# Technical Service Bulletin

<b>Subject:</b>  ACCUMULATION OF WATER AND/OR SAND IN FUEL-FILLER LID BOX	<b>Bulletin No.:</b> 09-040/23
	<b>Last Issued :</b> 11/14/2023

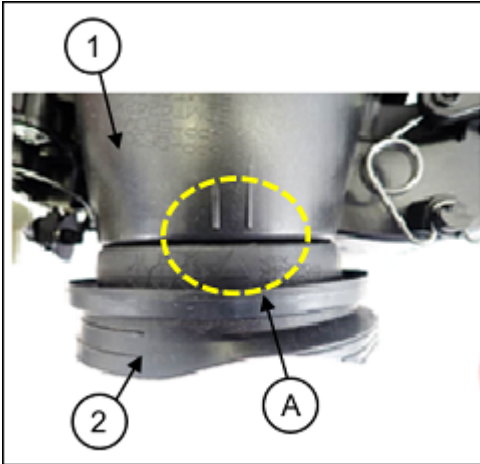
1. Verify the customer concern.
2. Replace the dust cover with a modified one according to the instructions on MGSS online FUEL-FILLER LID LOCK ACTUATOR REMOVAL/INSTALLATION.

Detail of area "A" from the image above.

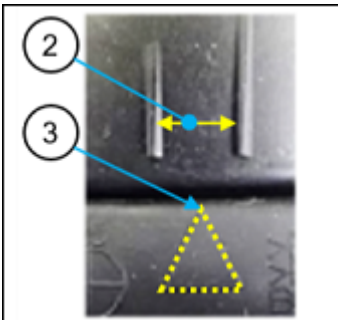
**NOTE:** Assemble the parts so that the top of the triangle (3) is located between the parallel lines (2).
